PROJECT OWNER : CK CAPITAL, LLC
PROJECT DESCRIPTION : CLEVELAND BROTHERS-MILESBURG
PROJECT ADDRESS : 4025N. EAGLE VALLEY ROAD, HOWARD, PA 16841
CONTRACTOR : KINSLEY CONSTRUCTION, INC.

DWG DESCRIPTION : GUARDRAIL & LADDER PLAN

SK#19
12-09-2025

1 SE713 ELEVATION

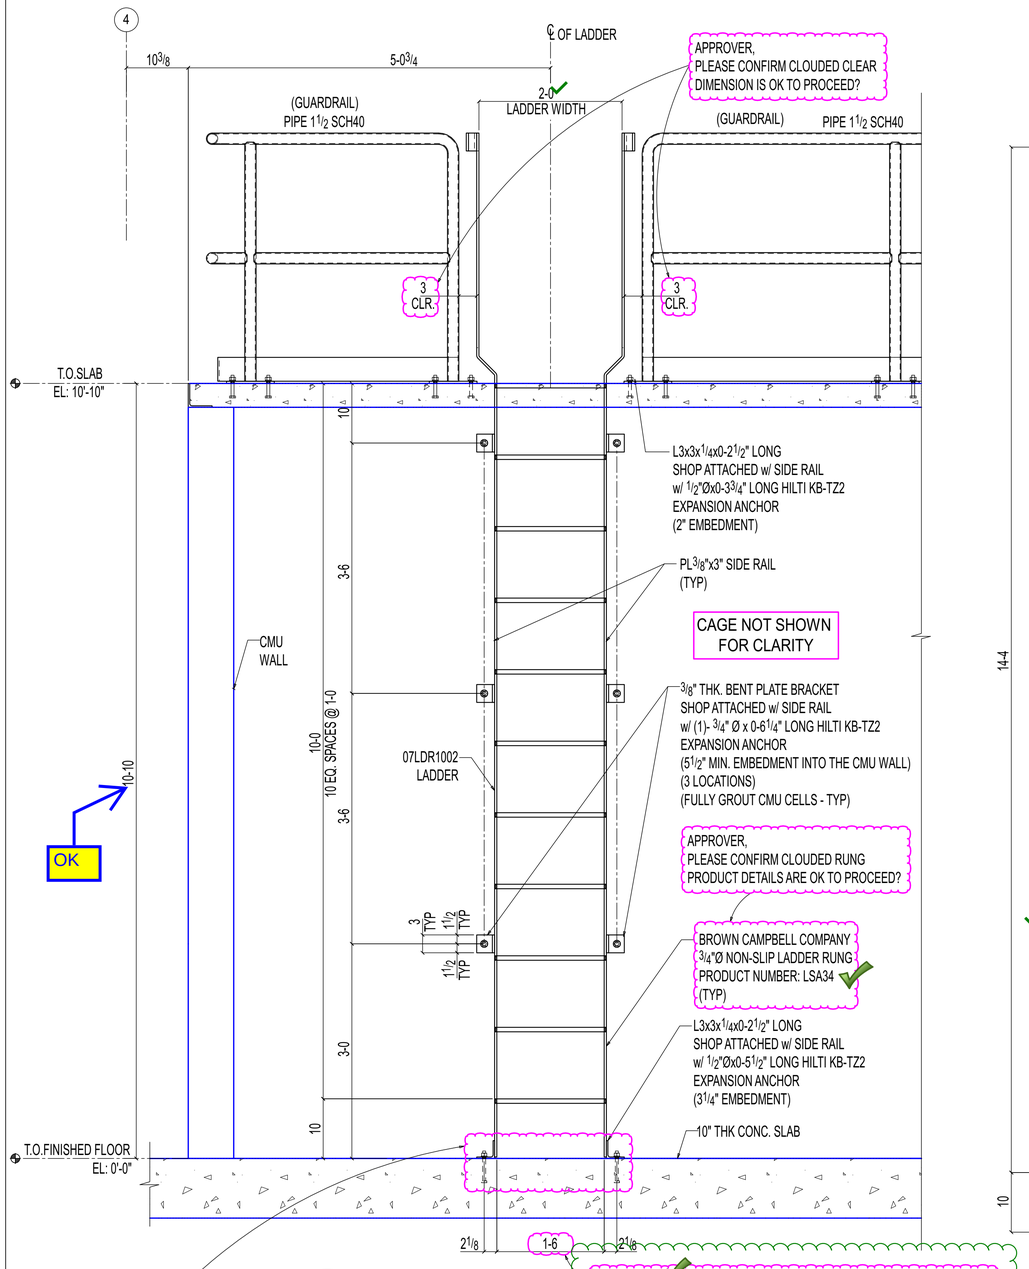
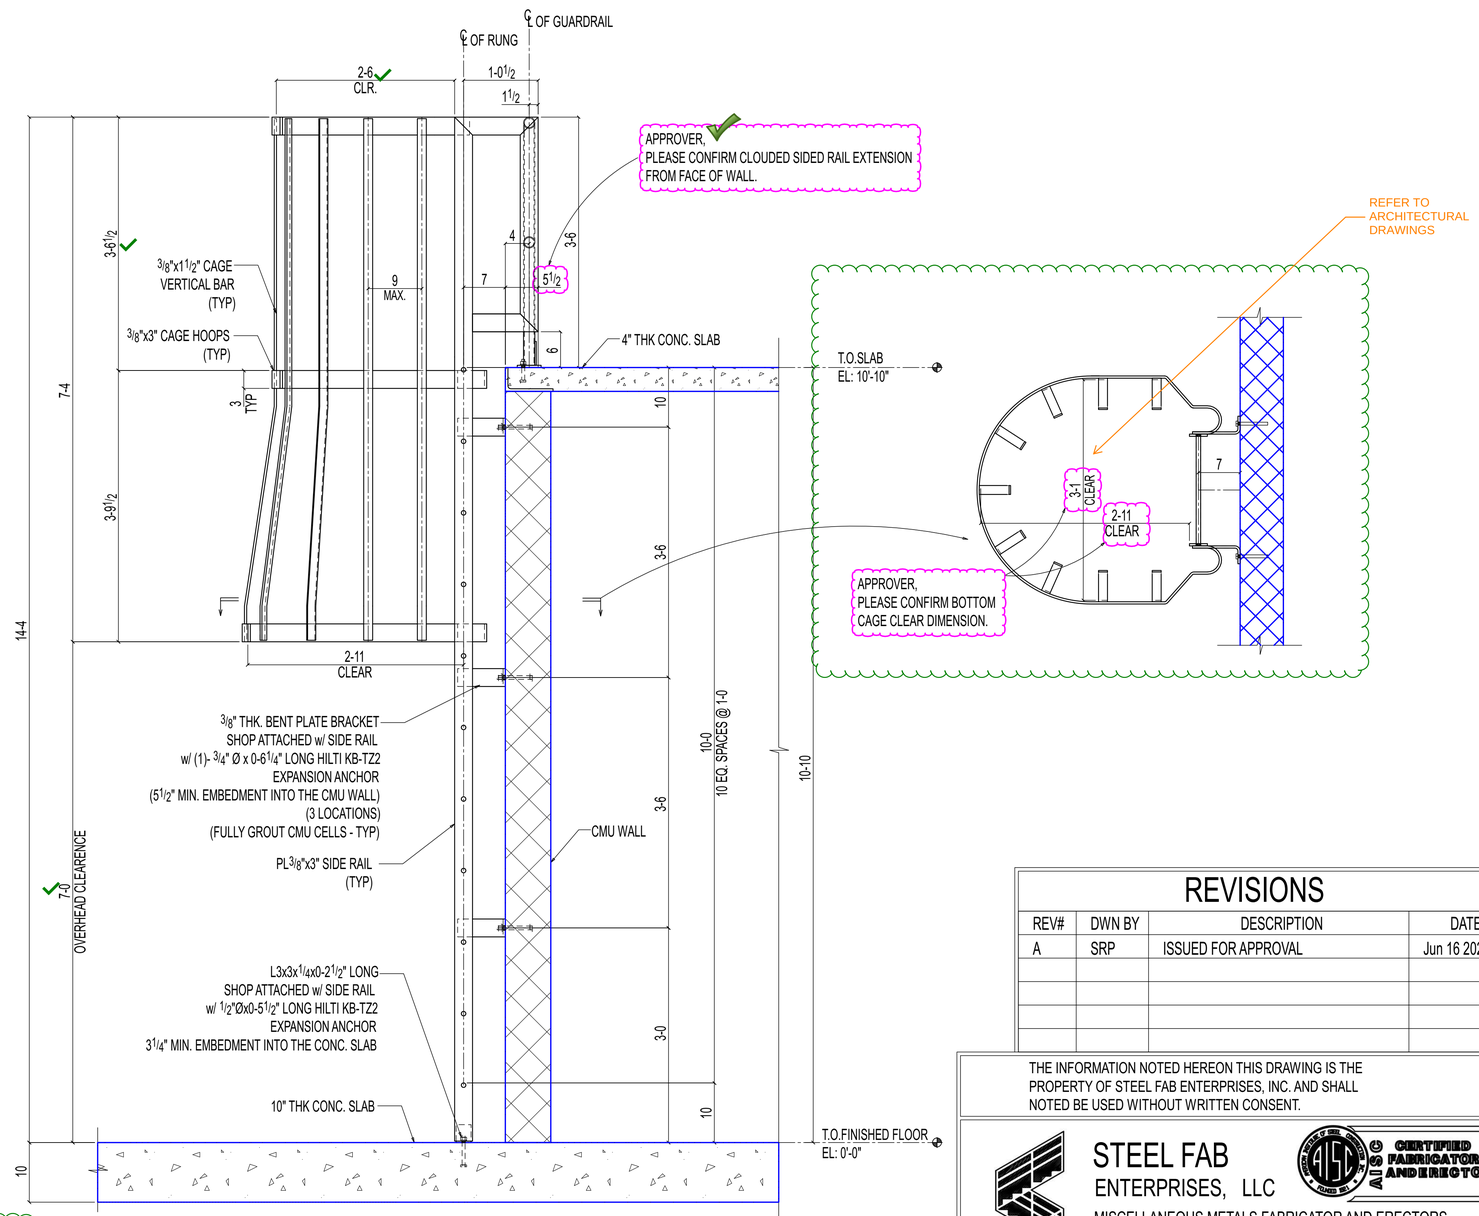
APPROVER,
ARCHITECTURAL DRAWING 6/A101 INDICATES LADDER WIDTH OF 1'-4",
BUT THE SPECIFICATION SHOWS A WIDTH OF 1'-6".
WE HAVE FOLLOWED THE 1'-6" LADDER WIDTH AS PER THE SPECIFICATIONS.
PLEASE CONFIRM IF THIS IS ACCEPTABLE TO PROCEED.

APPROVER,
AS PER ARCHITECTURAL DRAWING 6/A101, THERE IS A CLEARANCE BETWEEN
THE FLOOR AND THE LADDER. WE INTEND TO CONNECT THE LADDER DIRECTLY
TO THE FLOOR INSTEAD. PLEASE CONFIRM IF THIS IS ACCEPTABLE TO PROCEED.
